Submission

Draft Planning Scheme Amendment C109moor – Merrimu PSP

9 April 2026

Figure 2. WL10 Drainage Catchment

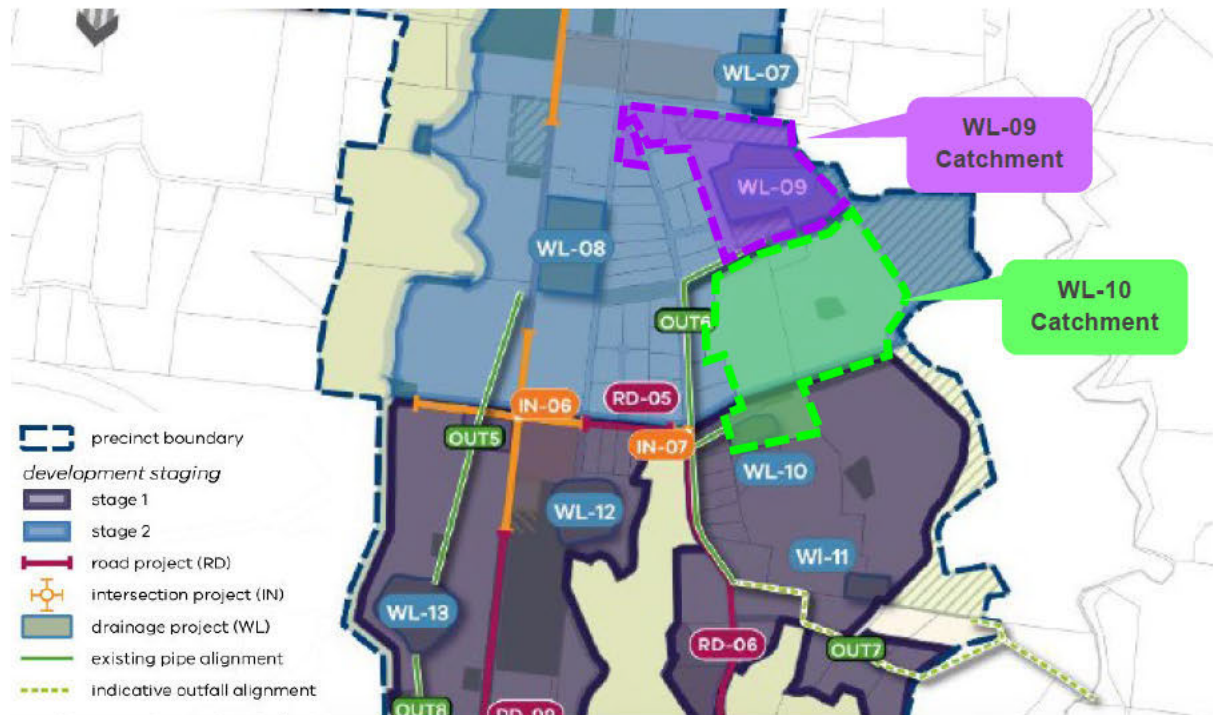
The Stage 1 boundary does not appear to have regard to drainage catchments, specifically WL-10 which is located in the northern extent of Stage 1 but the majority of its catchment is to the north within Stage 2, see Figure 2. The Stage 1 boundary more appropriately includes the WL-10 catchment within its confines, ensuring the development generating the need for WL-10 is included in the same development stage.

The remaining area of [REDACTED] is the WL-09 catchment which is also appropriate to include within Stage 1 as it benefits from the same access to services, planned community infrastructure and arterial road network. At a recent meeting with the VPA/DTP it was indicated that the exhibited staging boundary was not based on drainage catchments and that the precise boundary between stages 1 and 2 is under review. The need for review as it affects the [REDACTED] land is supported.

5. There may be delivery issues associated with a conservation area separating WL-07 and WL-09 if the intention is to link their drainage function.
6. WL-07 may most appropriately service the drainage catchment to its north, and WL-09 can service its local catchment within [REDACTED] (see Figure 2).

7. The location of WL-10 does not align with the location in the Colliers Stormwater Management Strategy which locates it where Local Park 22 (LP-22) in the PSP is shown.

- > Reduce the size of WL-09 to service the local catchment within [REDACTED]
- > Increase the size of WL-07 to service the larger catchment to the north of WL-09; and
- > Review the size of WL-10 and 11 if required.
